Director's Report

Project Name: 9101 Highland
 Description: Preliminary site plan approval recommendation & special land use approval
 Date on Agenda this packet pertains to: December 5, 2024

RE: 9101 Highland Road-Proposed Commercial Development- Preliminary Site Plan Review – 2nd Review

**Preliminary Site Plan / Special Land Use Review
for
White Lake Charter Township, Michigan**

DRAWING:
C-10

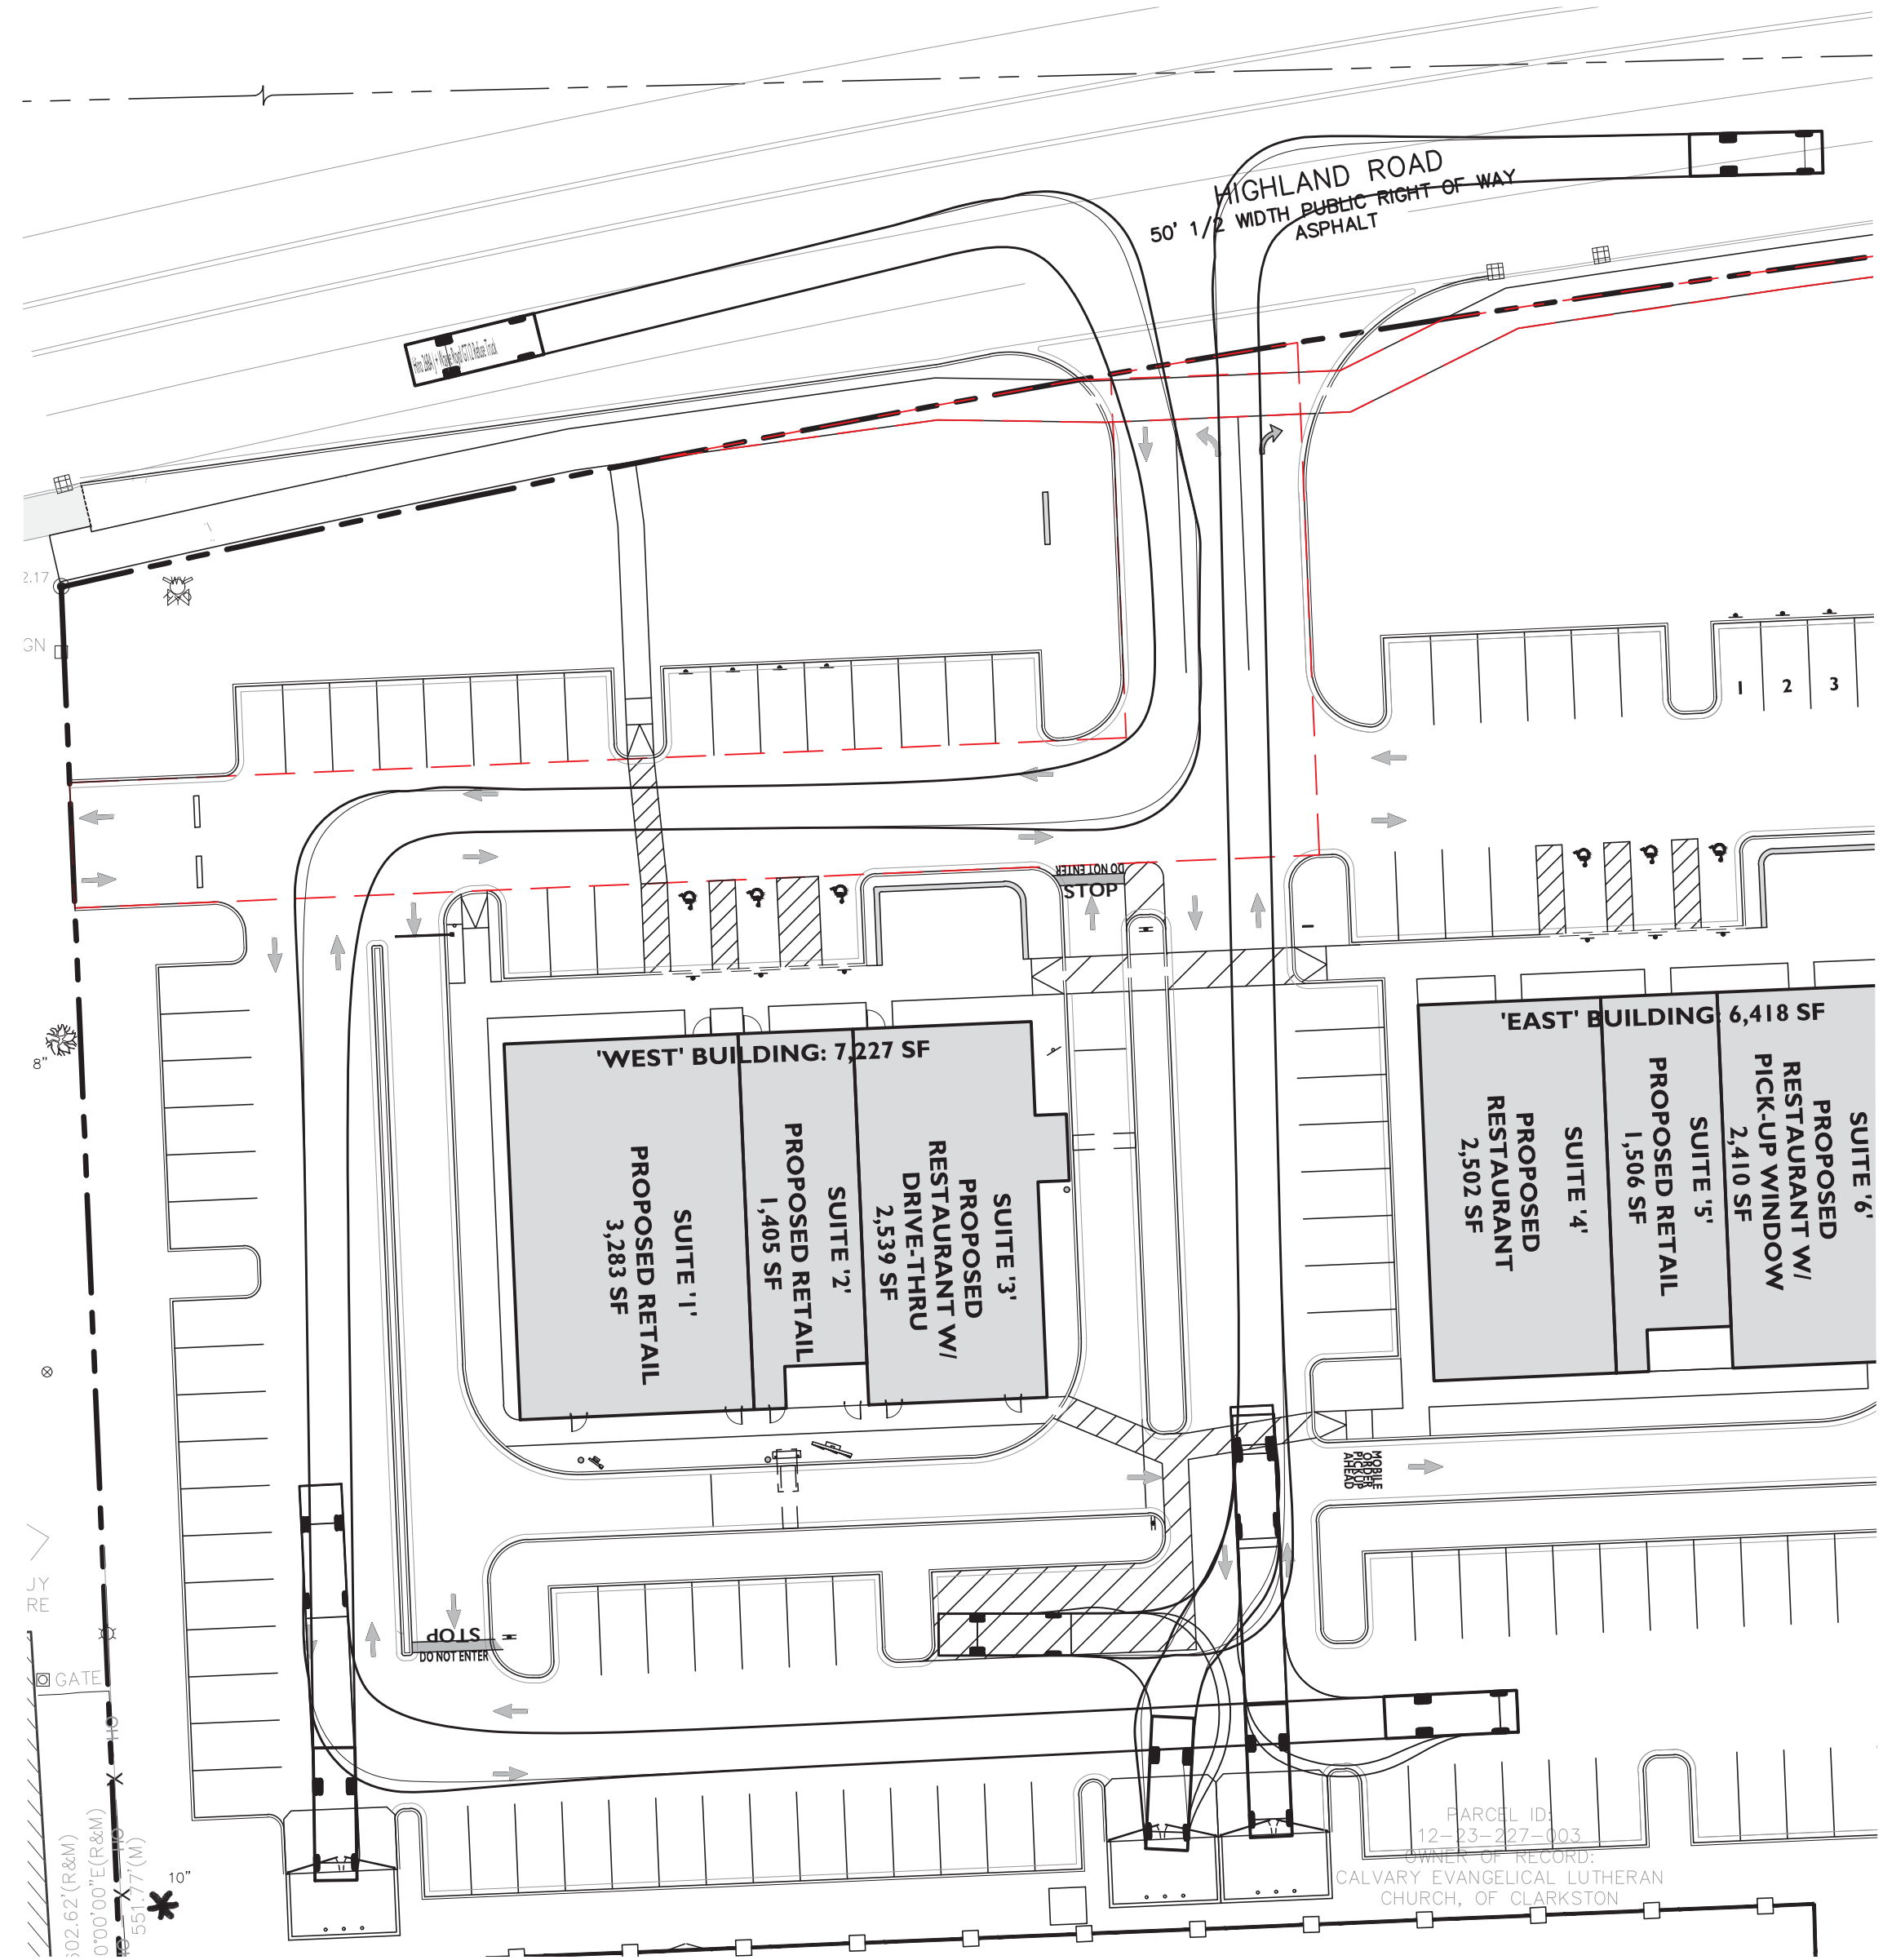
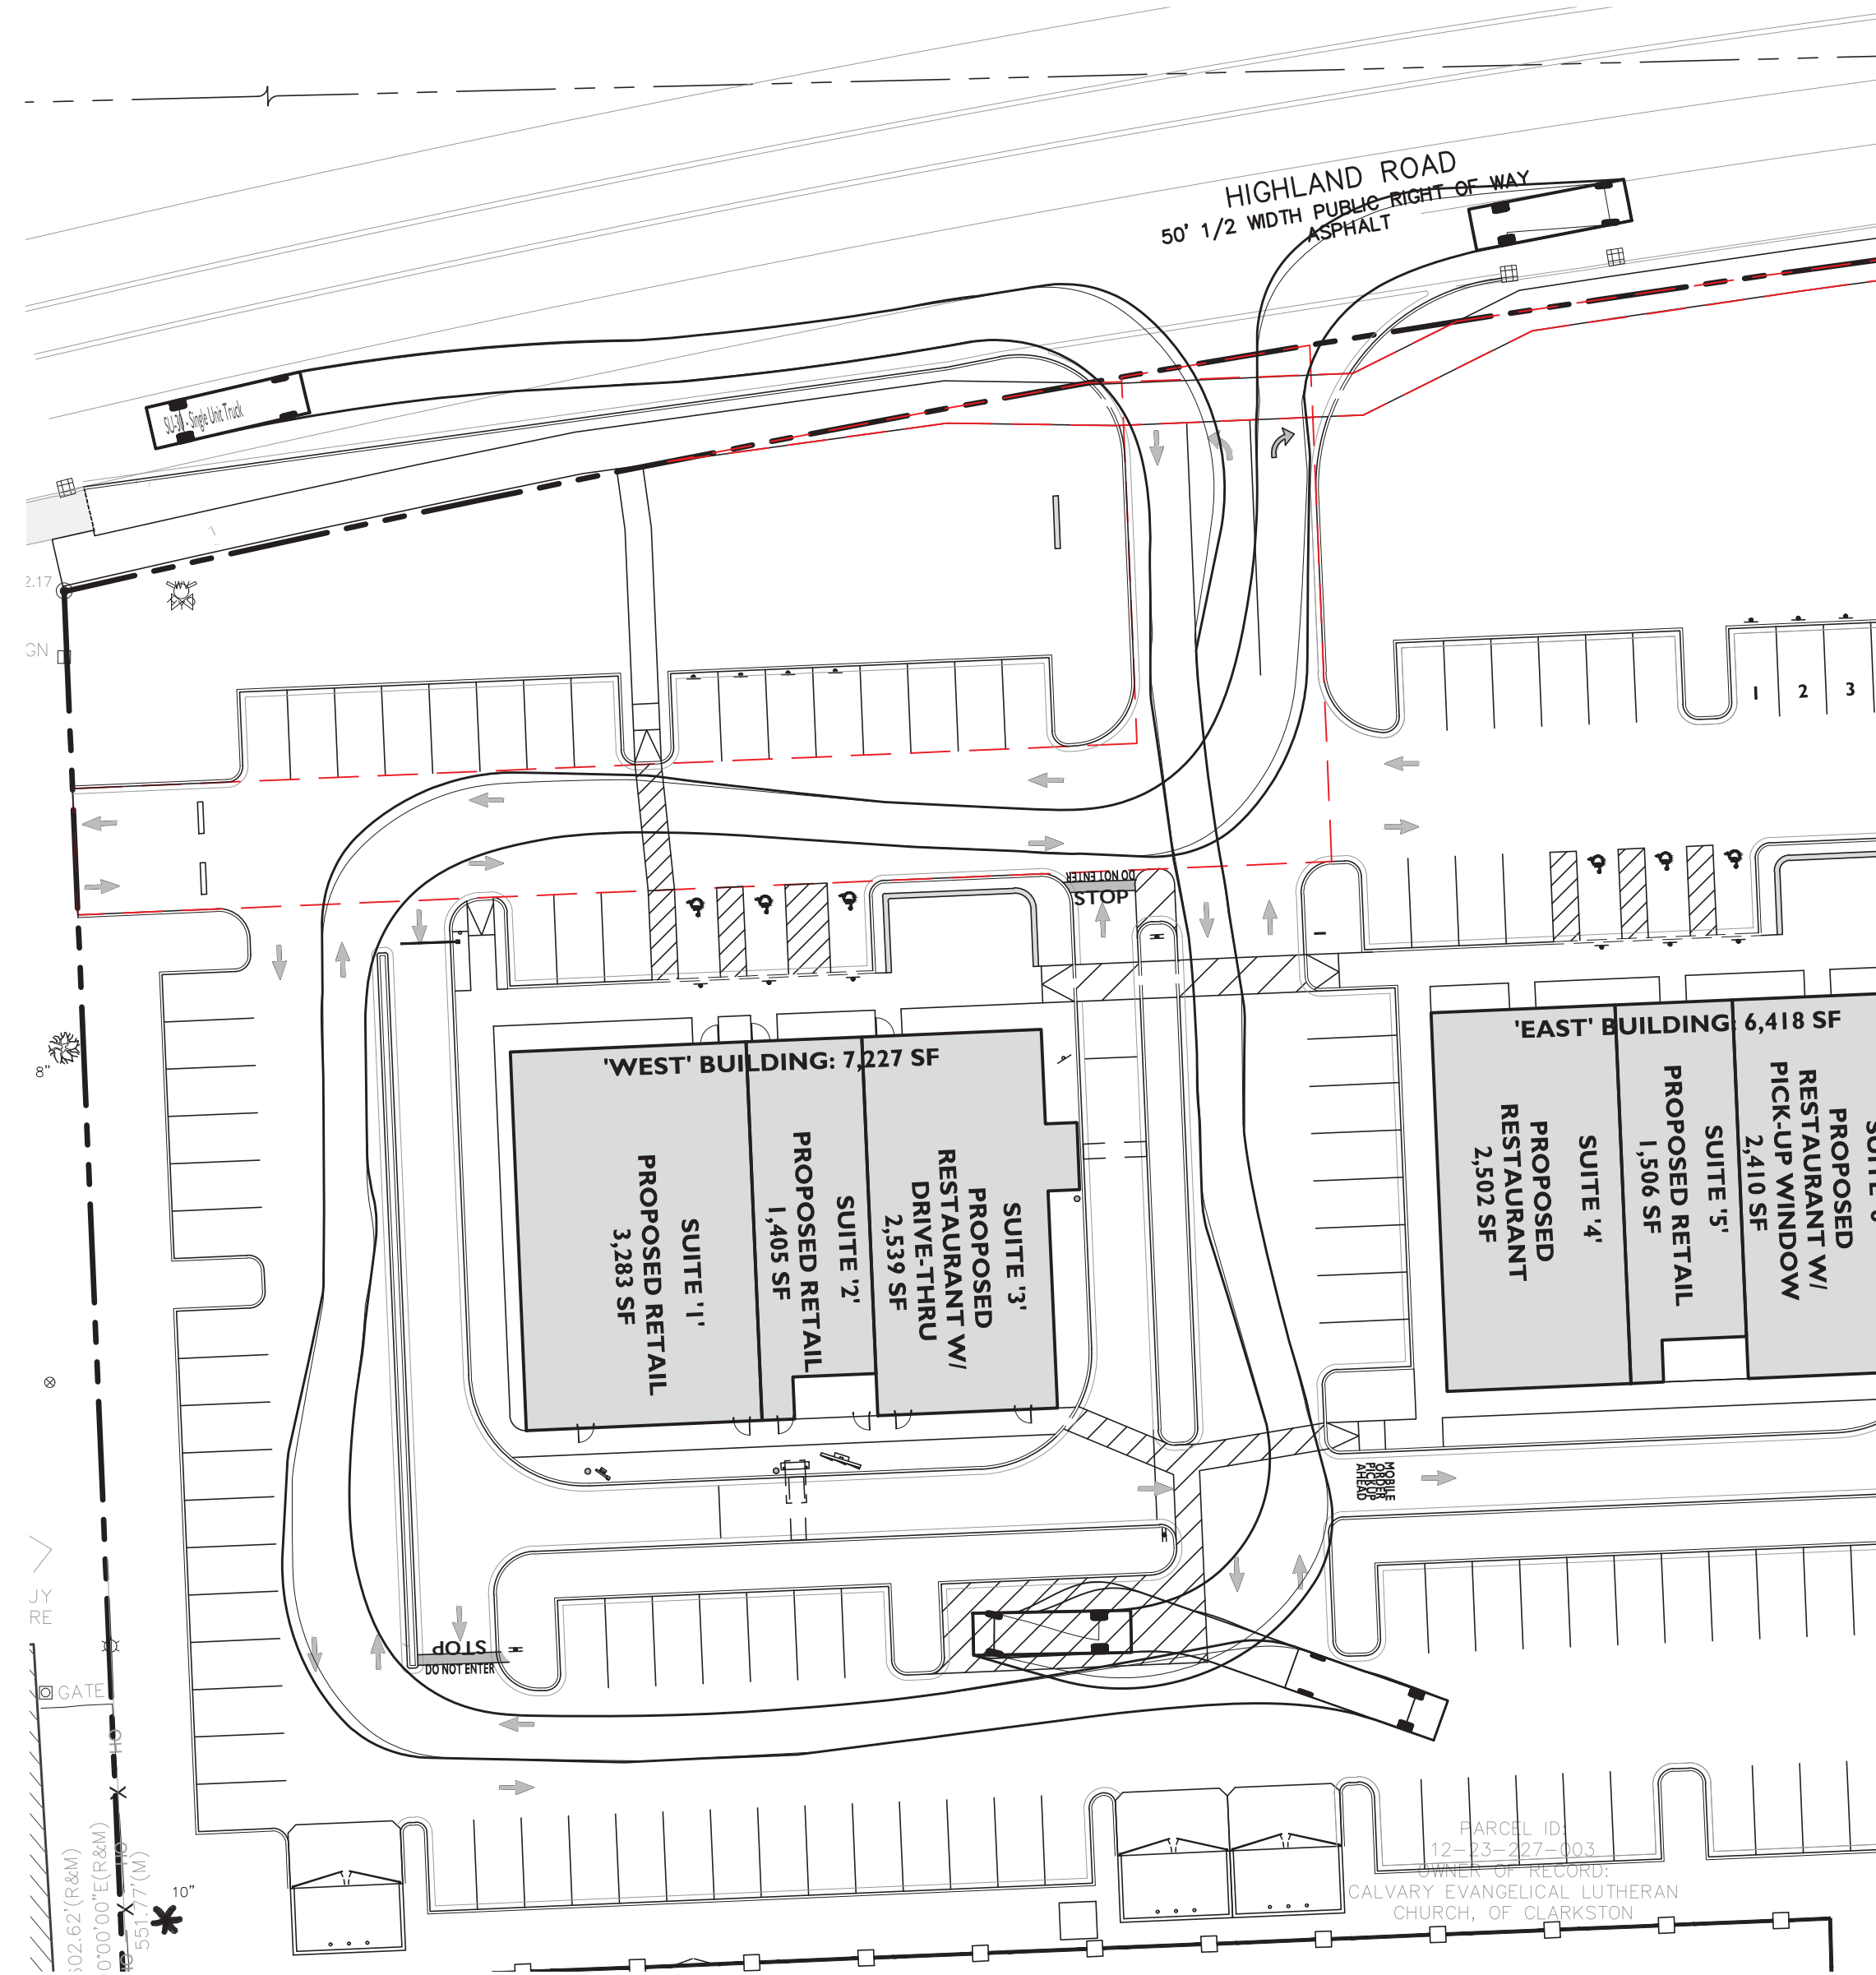
- d) *Provide plan indicating standard length fire truck access and turning radii so as to demonstrate adequate fire truck accessibility to and within the site. Comment addressed. Fire truck turning analysis has now been provided.*
